From: Kitchen, Robert [robert.kitchen@pgnmail.com]
Sent: Monday, June 18, 2012 4:54 PM
To: Nagel, Cheri
Cc: Karas, Rebecca; 'Mohammed.Shams@nrc.gov'; Patel, Pravin; Thomas, Vaughn; 'Bret.Taylor@nrc.gov'; Patterson, Malcolm; Snyder, Amy; Habib, Donald
Subject: Draft LNP RAI response - Seismic Evaluation
Attachments: RAI L-0998 Response Outline 06-18-12.pdf

NRC RAI

Response L-0998 Outline:

Figure RAI L-0998-1: Comparison of hard rock UHRS based on the EPRI-SOG/UCSS model from FSAR with hard rock UHRS using CEUS SSC model.

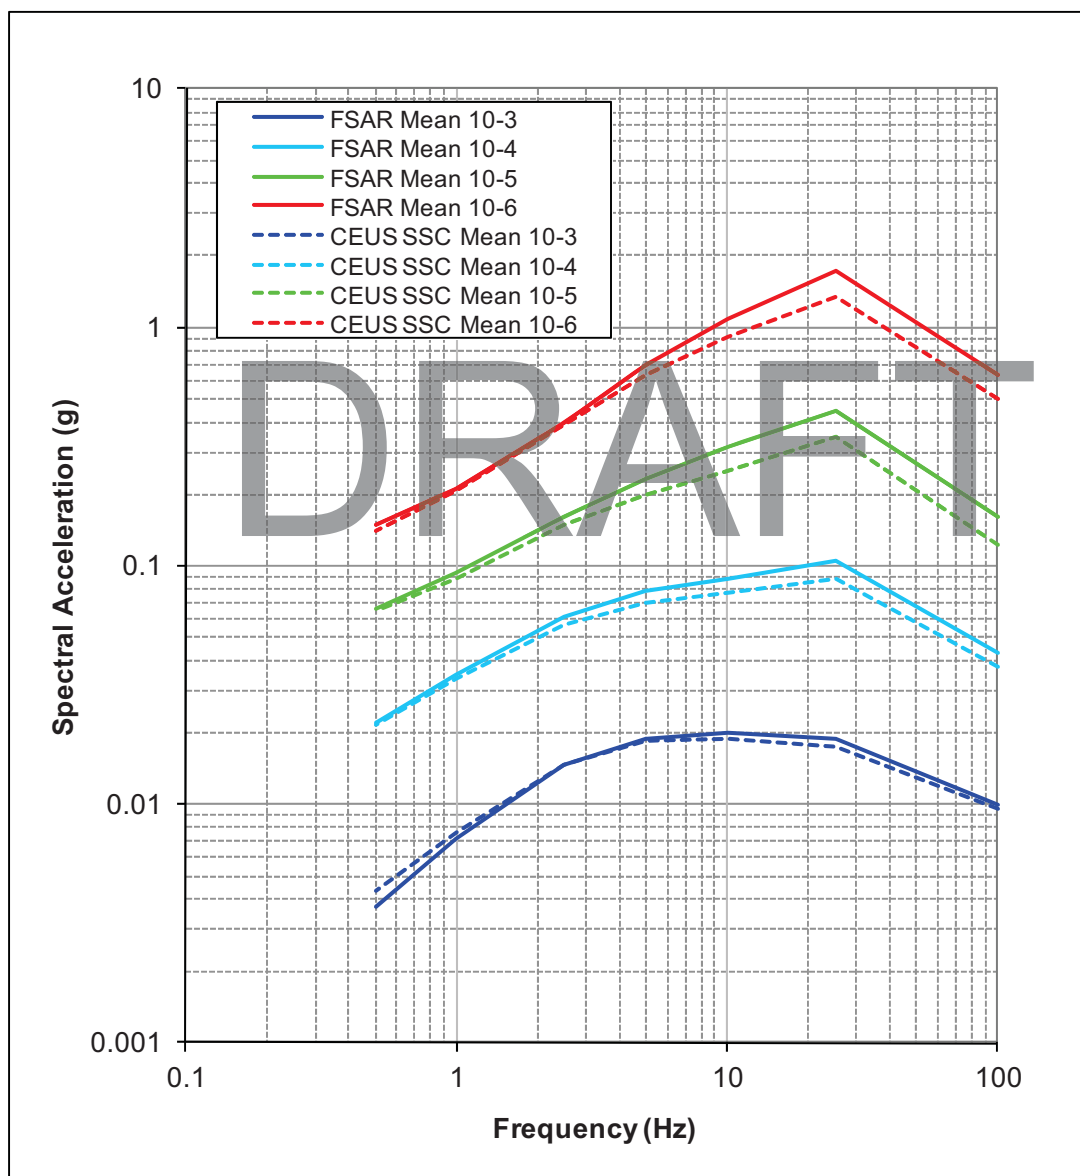
Evaluate the seismic hazard at your site against current NRC requirements and guidance and, if necessary, update the design basis and structures systems and components important to safety to protect against updated hazards (seismic portion only – of detailed Recommendation 2.1 – Enclosure 7 of SECY-12-0025).

Figure RAI L-0998-1 compares the hard rock UHRS based on the EPRI-SOG/UCSS source model used in the FSAR to the hard rock UHRS based on the CEUS SSC source model. The rock UHRS based on the CEUS SSC model are somewhat lower at spectral frequencies above 2.5 Hz and are similar to the Calculation LNP-0000-X7C-031 results for lower spectral frequencies. The only place where the CEUS SSC model produces higher motions is for the 10^{-3} UHRS at low frequencies. This higher hazard is likely due to the larger maximum magnitudes for the distributed seismicity sources in the CEUS SSC model.
